COVER SHEET

4734 NORTHEAST 78TH PLACE PORTLAND, OR 97218 SITE INFORMATION: BRIAN VAN HORN SYSTEM SIZE: 6.38 kW DC

Permit Revision Submittal Requirements and Application

Applicants will provide: A copy of this application Three (3) sets of plans that clearly reflect the proposed change(s). Drawings and calculations must be stamped and signed by the Architect and/or the Engineer of Record, if applicable.	One (1) copy of the original city approved permit drawings. (NOTE: If your project has an assigned process manager please contact them regarding submittal of the revision). Two (2) sets of calculations, if applicable Inspector's correction notice, if revision is due to an inspection correction Revision fee (paid at time of submittal)
Contact Information: Contact name Zach Scholad Address (270 S. (30) S. H430)	
Address (200) (0,50 2 14950 City State	Parmyting, Department & Blue raven, Com
Value of proposed revision #0.50 Job site address 4734 NE 78th PL	Issued permit # 17-164640
Description of revision fastened tech Char	ngel for Structural upgale
Fees:

EQUIP. DETAIL

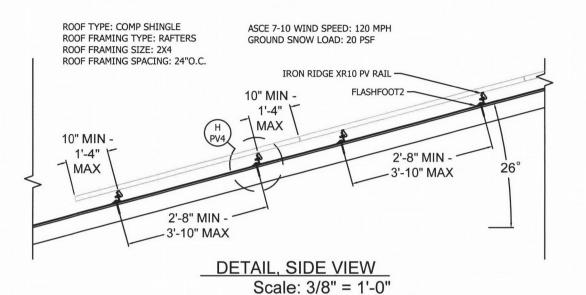
* SCOPE OF REVISION ROOF ATTACHMENTS SHALL BE SPACED NO GREATER THAN 24" ON CENTER IN ANY DIRECTION WHERE LOCATED WITHIN 3' OF A ROOF EDGE, HIP, EAVE, OR RIDGE OSSC 3111.5.3 ITEM 3.35 1'-6" -7'-3" 8'-6" 8'-6" 7'-3" 1'-6" 1220 S. 630 E STE. 430 AMERICAN FORK, UT 84003 800-377-4480 WWW.BLUERAVENSOLAR.COM CONFIDENTIAL - THE INFORMATION HEREIN CONTAINED SHALL NOT BE USED FOR THE BENEFIT OF ANYONE EXCEPT BLUERAVENSOLAR NOR SHALL IT BE DISCLOSED IN WHOLE OR IN PART TO OTHERS OUTSIDE RECIPIENTS ORGANIZATION EXCEPT IN CONNECTION WITH THE SALE AND USE OF THE RESPECTIVE B EQUIPMENT, WITHOUT THE WRITTEN PERMISSION OF BLUERAVENSOLAR LLC. *RAFTER UPGRADE - FULL SISTER (N) CONTRACTOR: BLUE RAVEN SOLAR 800.377.4480 2X4 TO (E) 2X4 RAFTERS WITH 16D PROJECT MANAGER: SCOTT GURNEY 385-498-4401 SINKERS SPACED 12" APART STAGGARD LBW LBW **LBW LBW** STRUCTURAL SIDE VIEW Scale: Not to Scale City of Portland
REVIEWED FOR CODE

COMPLIANCE RAFTERS 2X4 @ 24" OC 6'-3" 1'-6" 7'-5" AUG 0 1 2017 4734 NORTHEAST 78TH PLACE 10'-6" Permit Number SITE INFORMATION: PORTLAND, OR 97218 DC SYSTEM SIZE: BRIAN VAN HORN 6.38 kW DC 10'-5" OREGON *RAFTER UPGRADE - FULL SISTER (N)
2X4 TO (E) 2X4 RAFTERS WITH 16D
SINKERS SPACED 12" APART DRAWING BY MIKE PRATT EXPIRES 12/31/2017 DATE July 11, 2017 STRUCTURAL ONLY July 14, 2017 PROJECT NUMBER 34002723 LBW **LBW** STRUCTURAL SIDE VIEW EQUIP. DETAIL Scale: Not to Scale

ROOF ATTACHMENTS SHALL BE SPACED NO GREATER THAN 24" ON CENTER IN ANY DIRECTION WHERE LOCATED WITHIN 3' OF A ROOF EDGE, HIP, EAVE, OR RIDGE OSSC 3111.5.3 ITEM 3.35
